Proposed Revisions to a Standard Plans Index

Index Number: 102-110

Sheet Number (s): 4 of 17

Index Title: Type K Temporary Concrete Barrier System

TYPICAL SECTION
ADJACENT TO RETAINING WALL WITH SOIL BACK-FILL

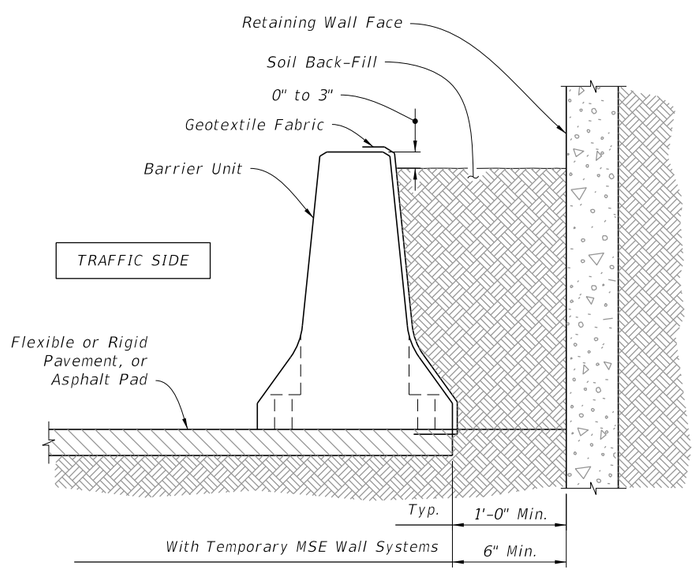
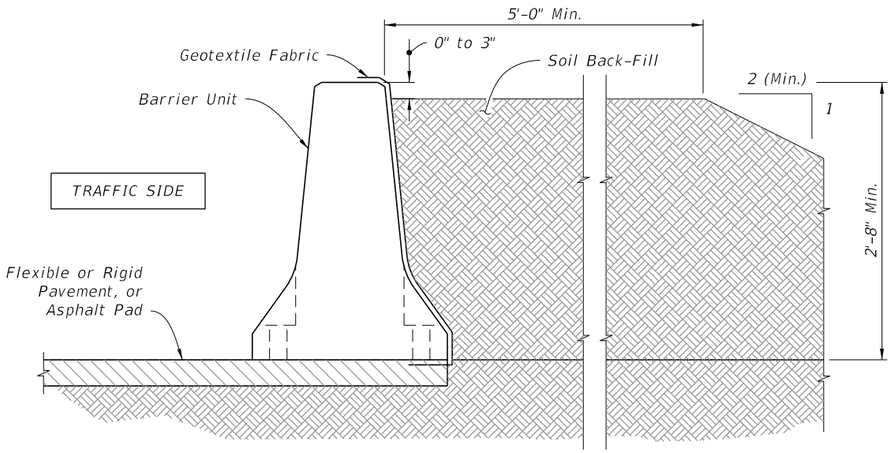
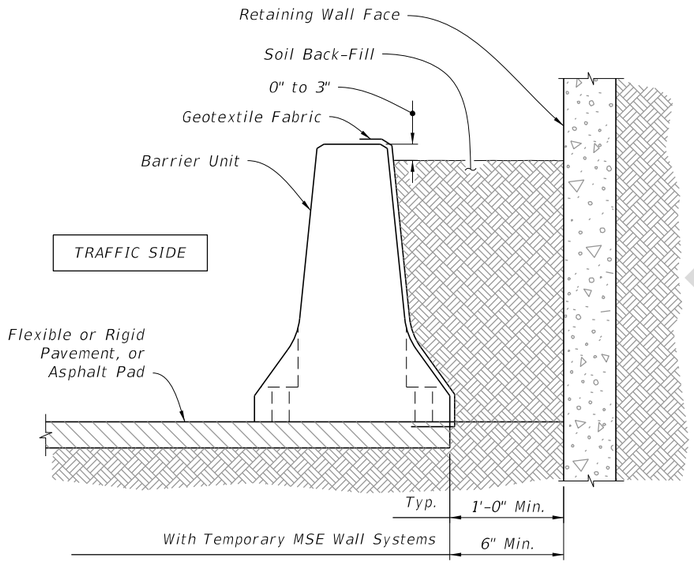
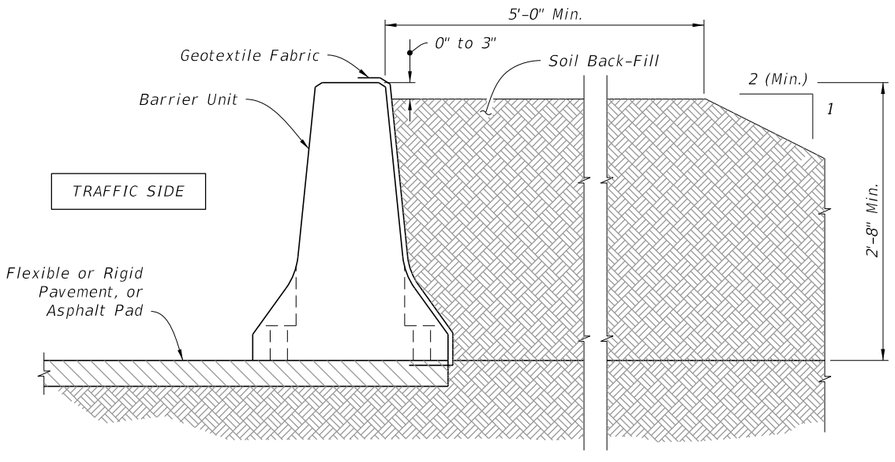
Sheet 4: Updated the GEOTEXTILE FABRIC Note: GEOTEXTILE "Provide and install Type D-5 geotextile fabric in accordance with Specifications 514 to contain Back-Fill Materials behind the Barrier Units."

UPDATED: Provide and install Type D-5 geotextile in accordance with Specifications 514 to contain Back-Fill Materials behind the Barrier Units.

GEOTEXTILE FABRIC: ~~Provide Type D-5 Geotextile Fabric in accordance with Specification 985 to contain Back-Fill Material behind Barrier Units.~~ Geotextile ~~Fabric~~ may be continuous over the length and height of the installation or may be individual pieces as required to cover the Lift/DrainSlots and open vertical joints between Barrier Units.

GEOTEXTILE: Provide and install Type D-5 geotextile in accordance with Specification 514 to contain Back-Fill Material behind the Barrier Units. Geotextile may be continuous over the length and height of the installation or may be individual pieces as required to cover the Lift/DrainSlots and open vertical joints between Barrier Units.
